NOTICE OF MEETING

A meeting of the **ARGYLL AND BUTE LOCAL REVIEW BODY** will be held in the **MEMBERS ROOM, KILMORY, LOCHGILPHEAD** on **THURSDAY, 17 JUNE 2010** at **10:30 AM**, which you are requested to attend.

LAND TO SOUTHWEST OF
COTTAGE 3, BALLOCHYLE
FARM, PA23 8RD

**TOWN AND COUNTRY PLANNING (SCOTLAND) ACT 1997;
PLANNING APPLICATION REF. 09/01308/PP
ERECTION OF DWELLINGHOUSE, FORMATION OF CAR PARKING, INSTALLATION OF
SEPTIC TANK AND CREATION OF PRIVATE WATER SUPPLY;
LAND SOUTH WEST OF COTTAGE 3, BALLOCHYLE FARM, SANDBANK, DUNOON,
ARGYLL.**

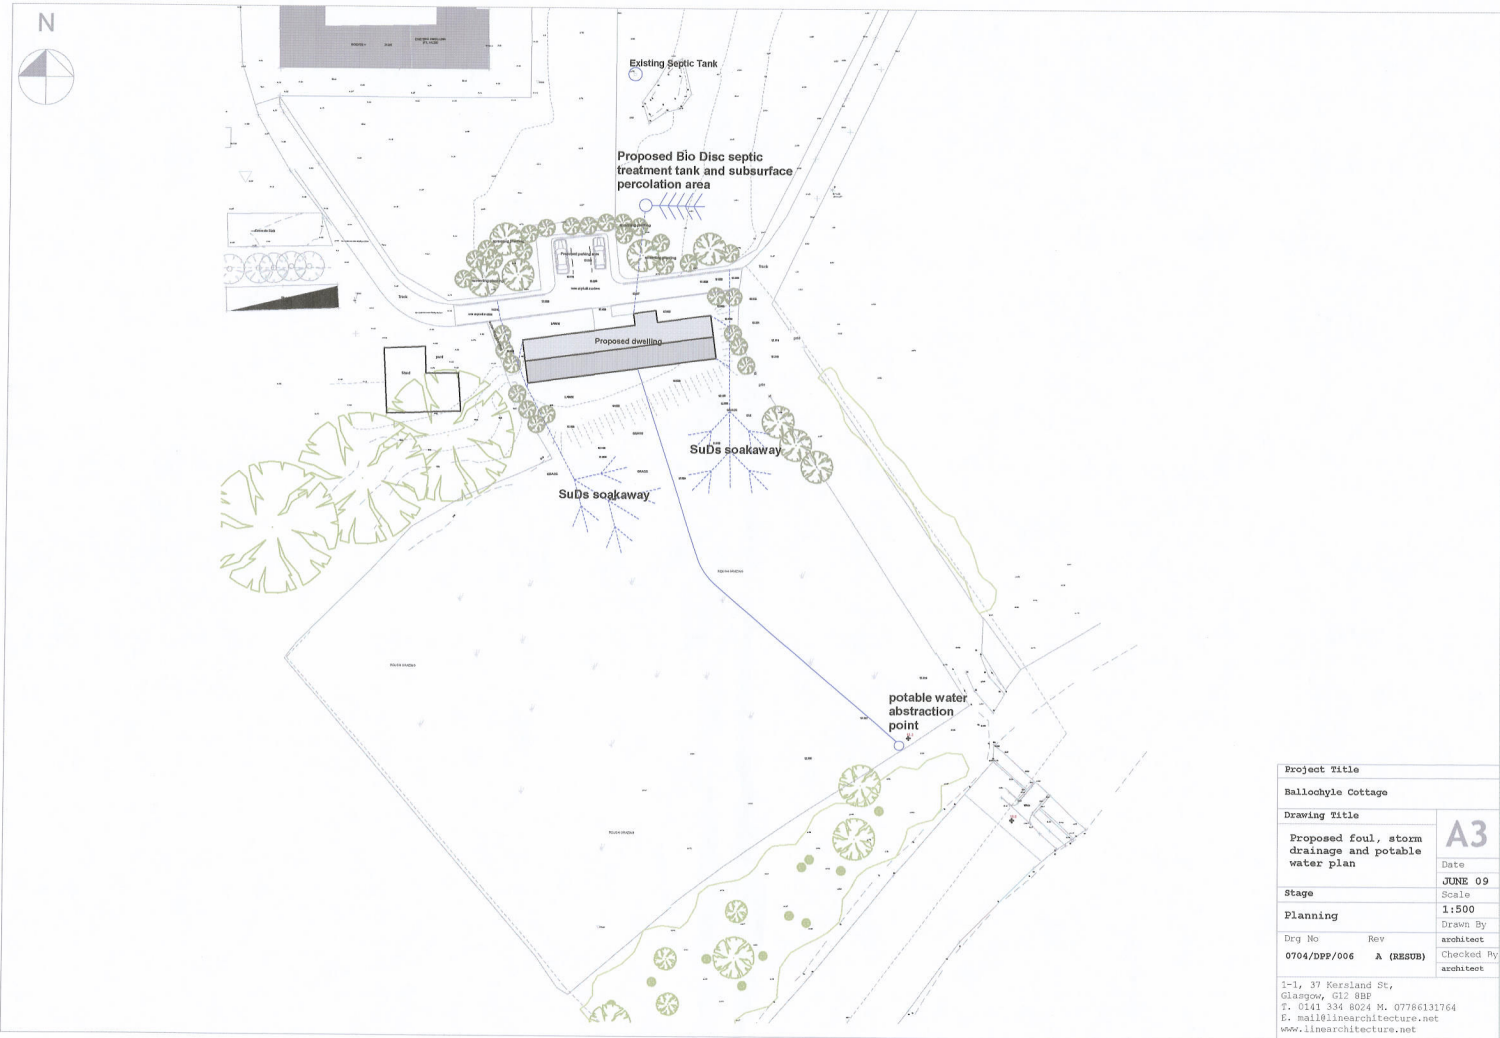
3. The applicant has failed to provide accurate information in respect of foul drainage proposals for the application site. The lack of precise foul drainage arrangements is contrary to: policy LP SERV 1 – Private Sewage Treatment Plants and Wastewater Systems of the Argyll and Bute Local Plan (August 2009), which presume against the nature of the development proposed.

4 *The applicant has failed to provide accurate information in respect of surface water drainage proposals (SuDS) for the application site. The lack of precise drainage arrangements incorporating a SuDS scheme to alleviate potential flooding of the site and adjacent properties and their land is contrary to: Scottish Planning Policy SPP7 – 'Planning and Flooding' and PAN 69 'Planning and Building Standards Advice on Flooding'; Policies STRAT SI 1 'Sustainable Development' and STRAT DC10 'Flooding and Land Erosion' of the Argyll and Bute Structure Plan 2002; and policies LP SERV 2 – Sustainable Drainage Systems (SuDS), LP SERV 3 'Drainage Impact Assessment' and LP SERV 8 'Flooding and Land Erosion' of the Argyll and Bute Local Plan (August 2009), all of which presume against the nature of the development proposed.*

However we did indicated in drawing no. 0704/DPP/006 Rev A a SuDs drainage system to incorporate storm water soakaways. This is clearly indicated and whilst not at this stage providing precise details of the drainage specification, experience tell us this level of detail is usually sufficient for determining a planning application and that detailed drainage design is handled by a certified engineer at the subsequent building warrant phase.

figure 3 - harmony with topography

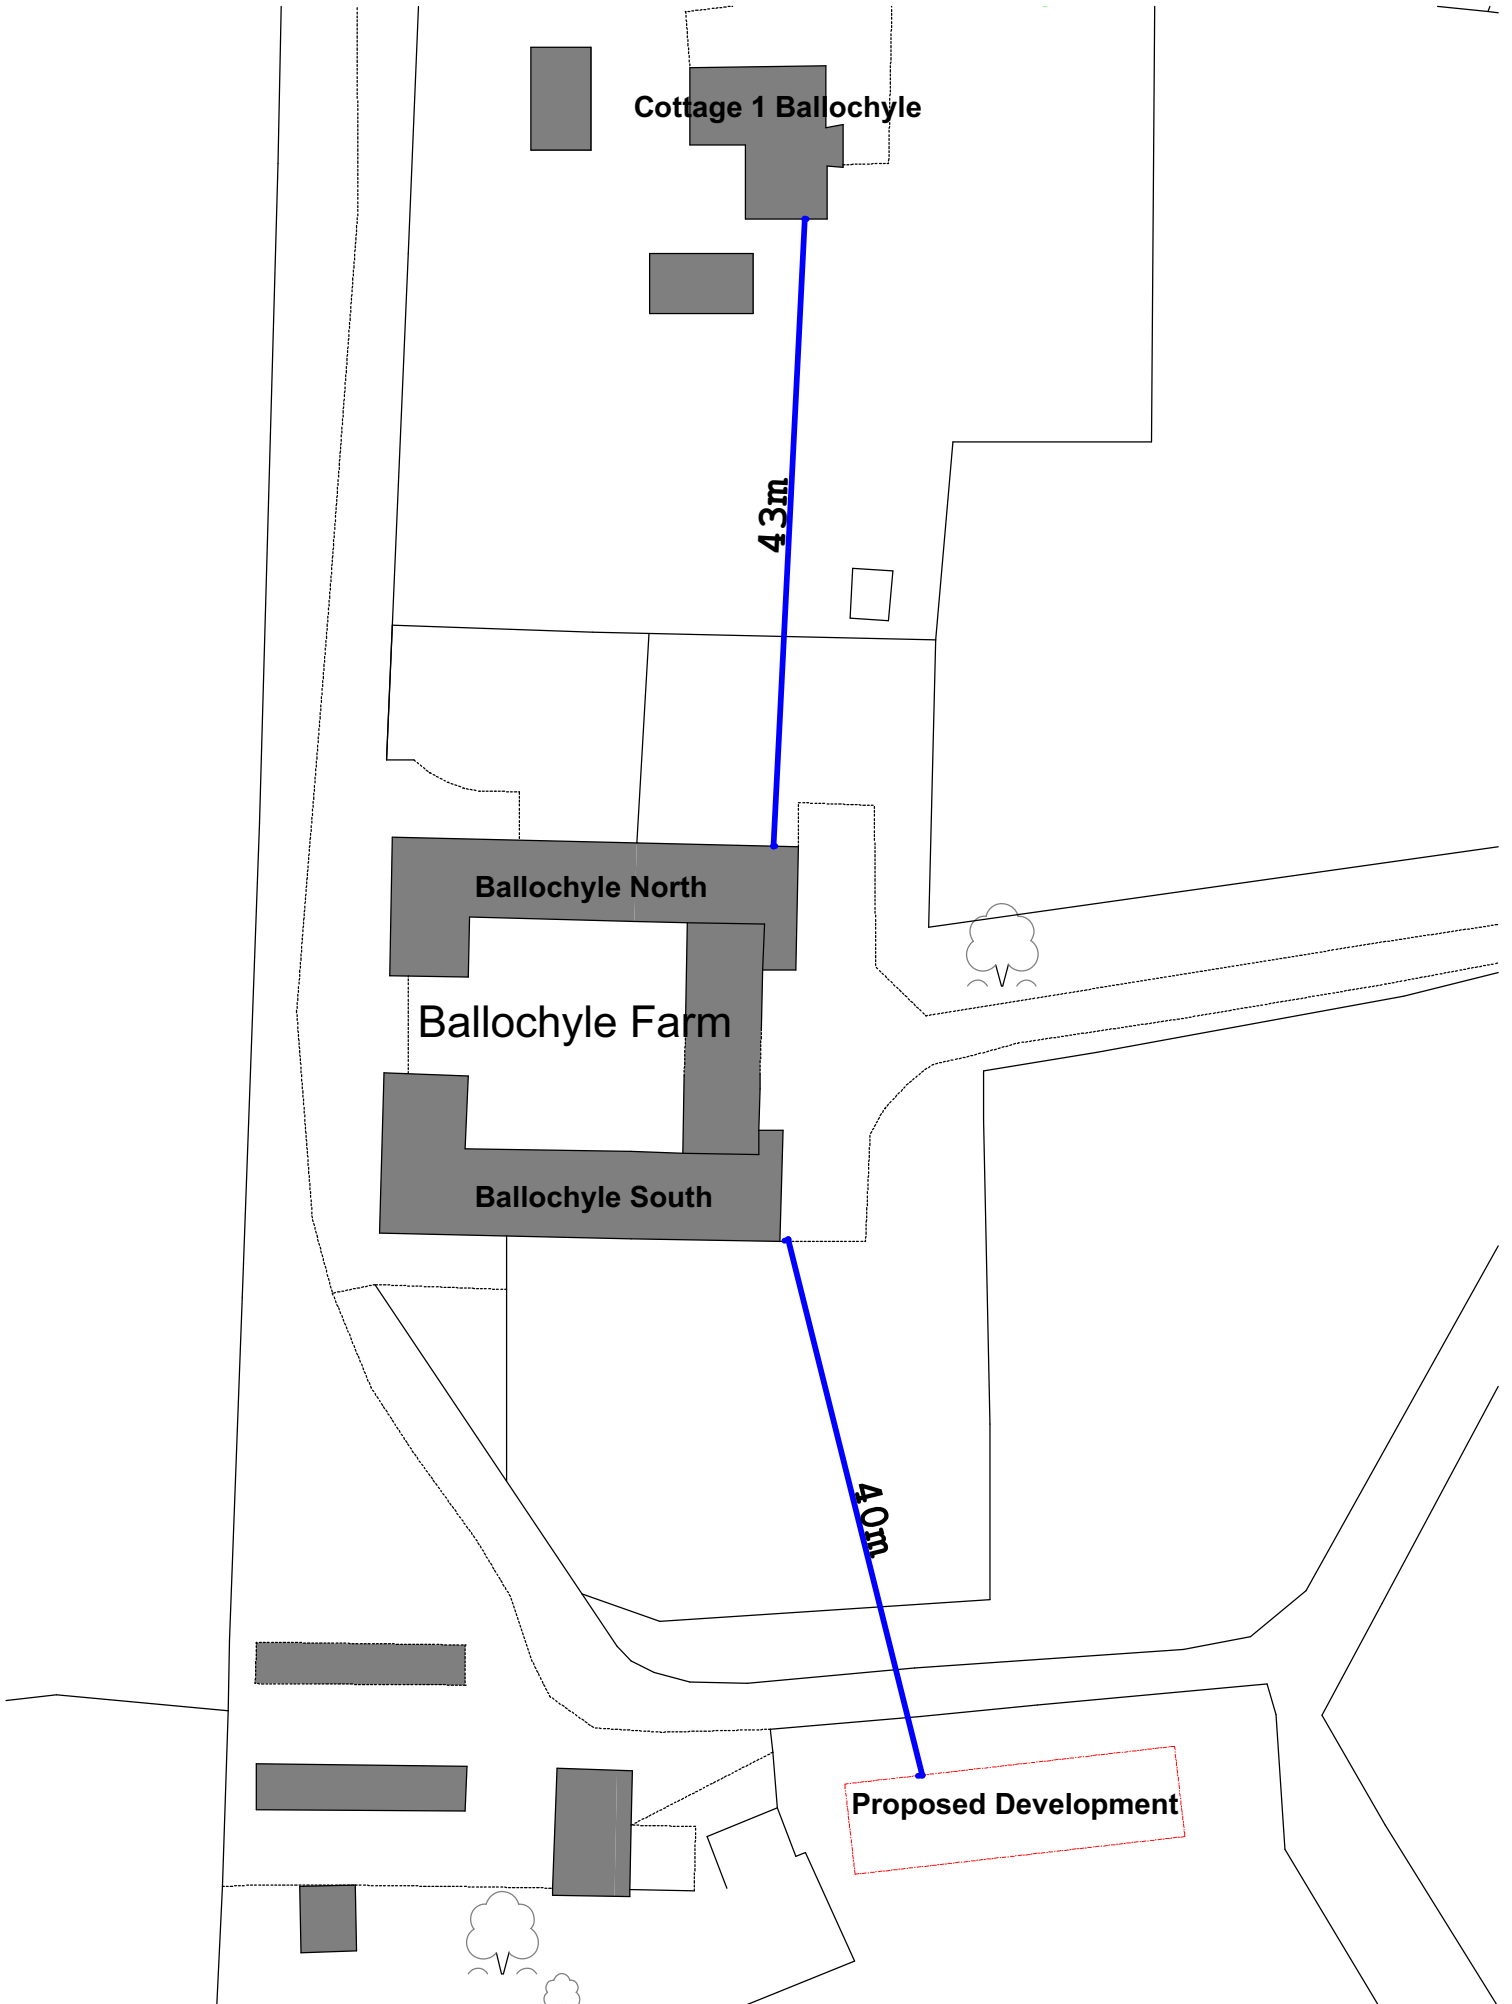
We find it very difficult to understand why the planning officer considers that the proposed dwelling would constitute “cramming of buildings close to the Ballochyle farm buildings” when the proposed dwelling is some 41 metres from the existing steading. The existing house to the north (Ballochyle Cottage 1) is located only 43m from the steading and this is not mentioned. (See Figure 1 overleaf). This fact it would seem undermines any claim that the position of the proposed dwelling would constitute “cramming”.

The proposed siting of the longhouse has been very carefully considered with the existing topography. This proposal has been designing with the aid of 3d topographical land modelling and computer building modelling to ensure that the proposal is harmonious with its topographical and arboreal context. In a rural location we feel that this is as important, if not more so than harmony with the existing built context. (See figure 2 overleaf)

The proposed dwelling has been conceived as a continuation of the ridge that runs west from the site and forms a topographical continuum that encloses and rounds off the Ballochyle cluster at the location of the proposed dwelling. This topography and existing arboreal features create a sheltered site and the placing of a dwelling at this location in turn creates a private amenity area between the dwelling and the river. We feel that this siting is perfectly logical and not only complements the topography but rounds off this cluster of buildings whilst creating a beautiful setting for a rural home. (See figure 3 overleaf)

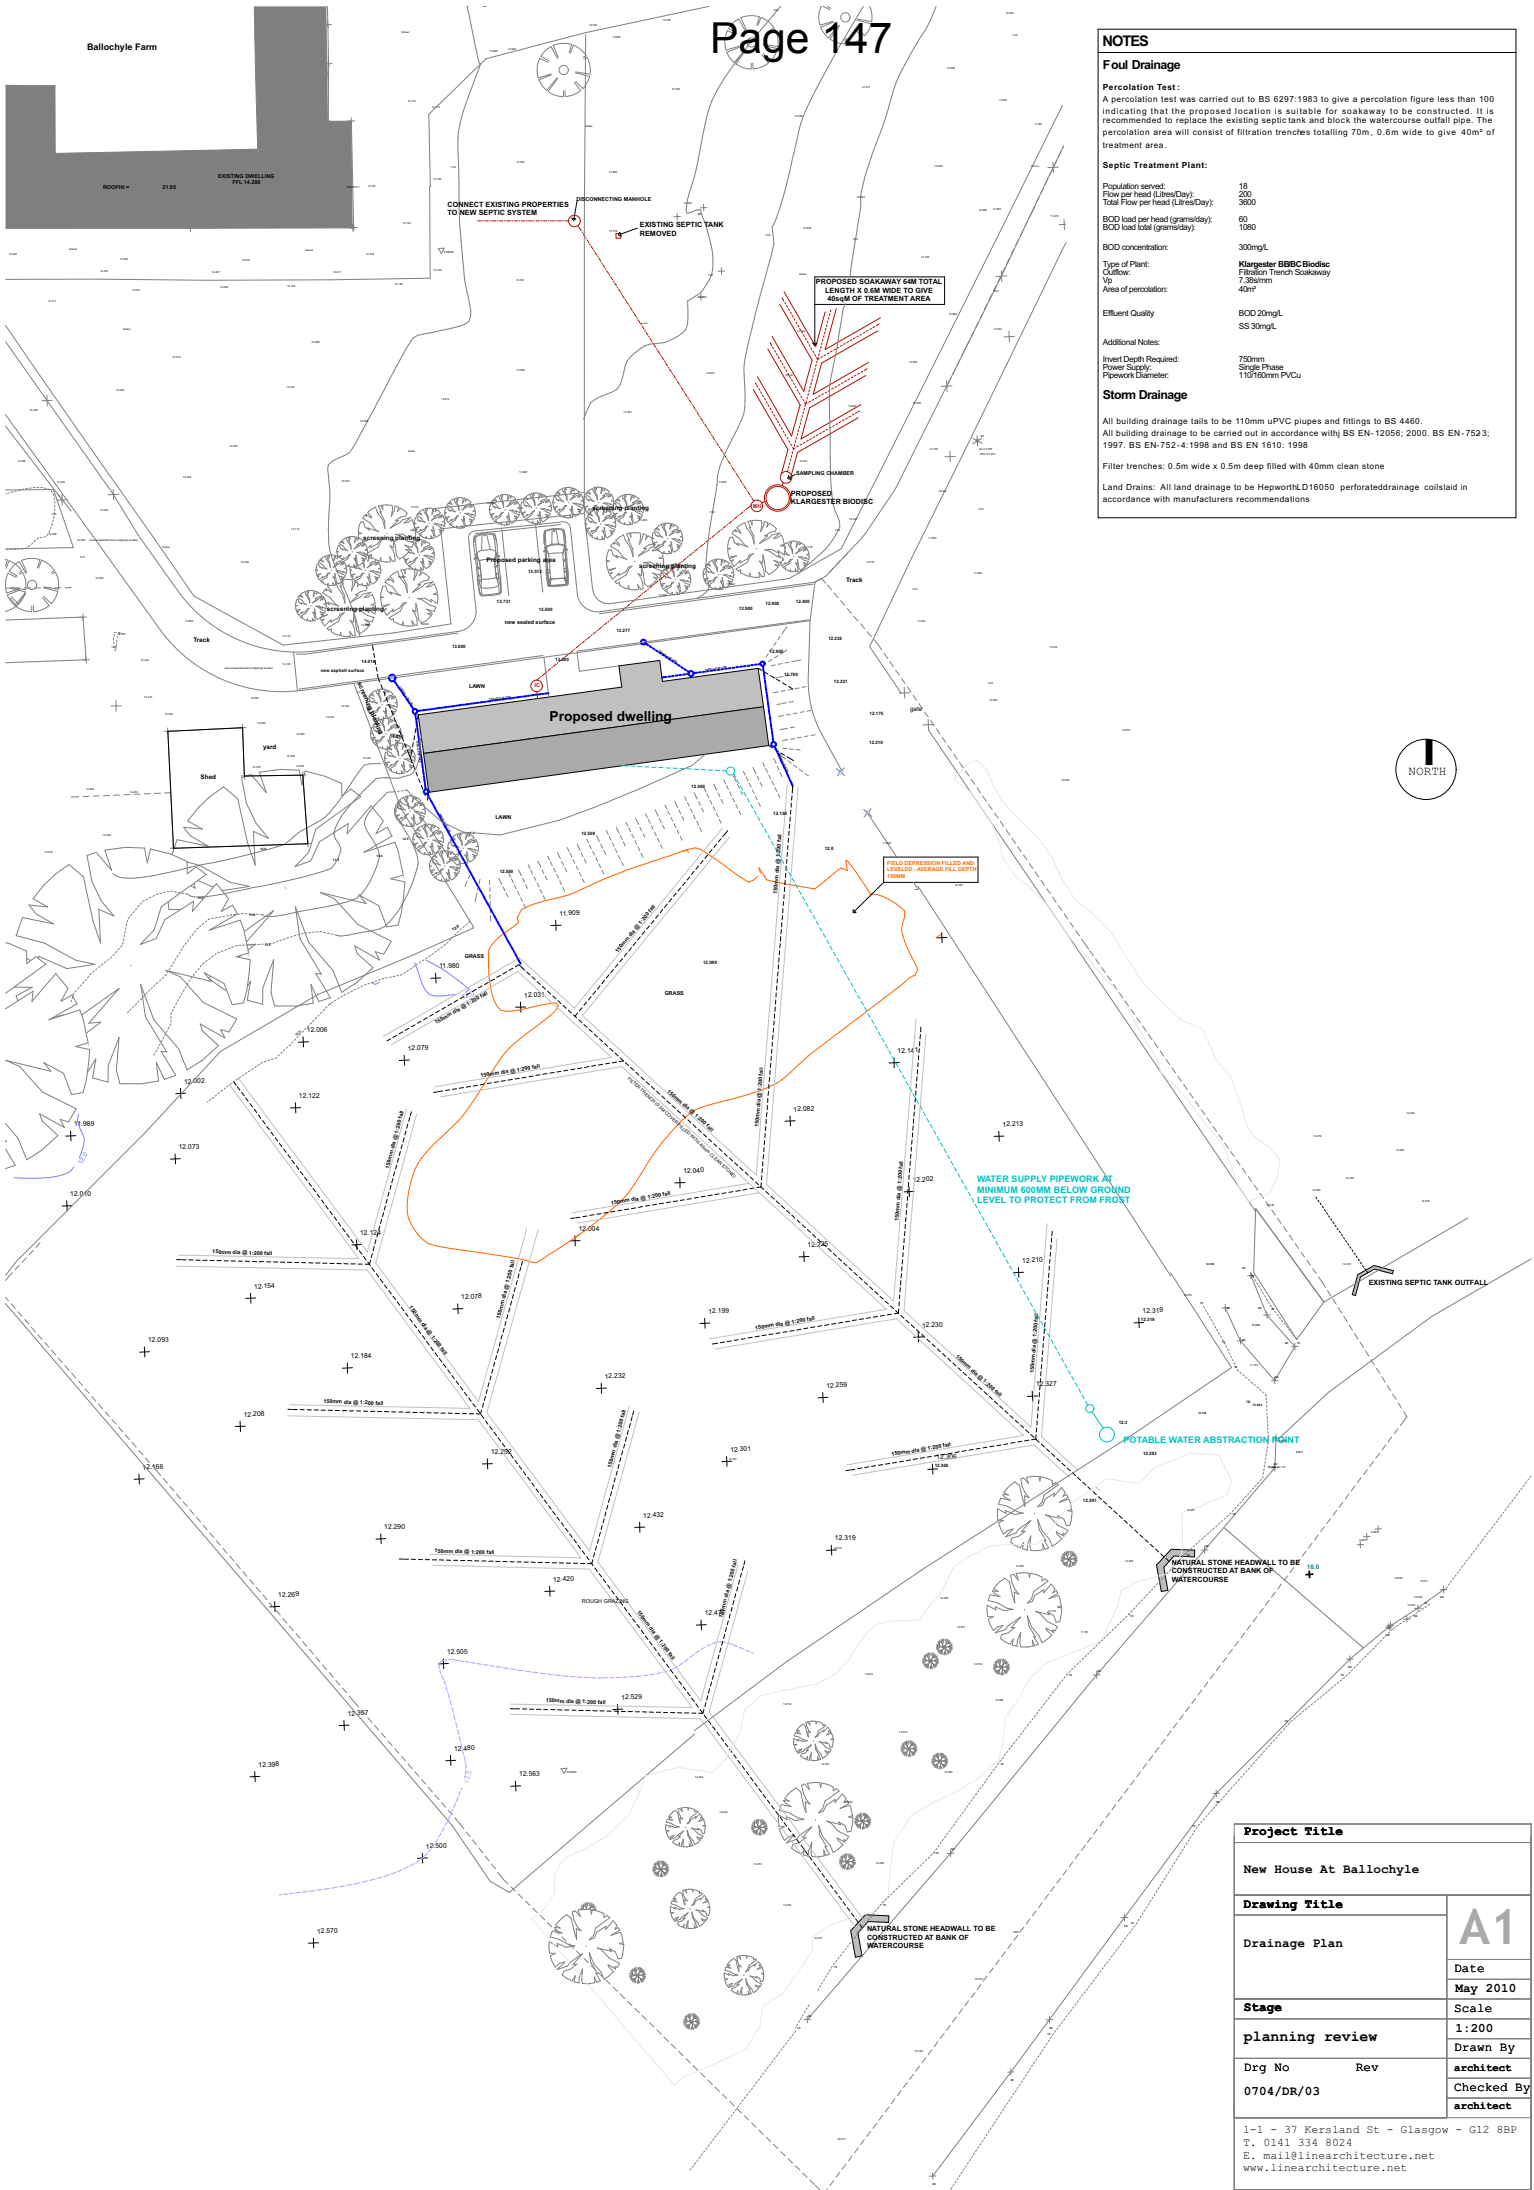
We find the planning officer's defence of the lack of information requests slightly puzzling as this application not only took five months to determine but the same planning officer dealt with the earlier withdrawn scheme (09/00612/DET) which was almost identical apart from the inclusion of a private water supply. Therefore this application has been sitting on the case officer's desk with the same foul drainage and SuDs proposals from May 2009 to January 2010, during which time we instigated at least two meetings, instigated numerous telephone conversation and sent emails requesting if additional information was required. Not once was a request for any further information regarding SuDs, Foul drainage or flooding ever requested.

We have now included a detailed SuDs drainage design and a detailed proposal for foul water treatment. This represents further considerable expenditure for my clients for works which we still maintain are not required at this stage, especially if the planning officer has objections in principle for the scheme itself. However we are professionally obligated to advise our clients that this information is now a necessity as it has been re-iterated in the planning officer's response to our initial statement of appeal.
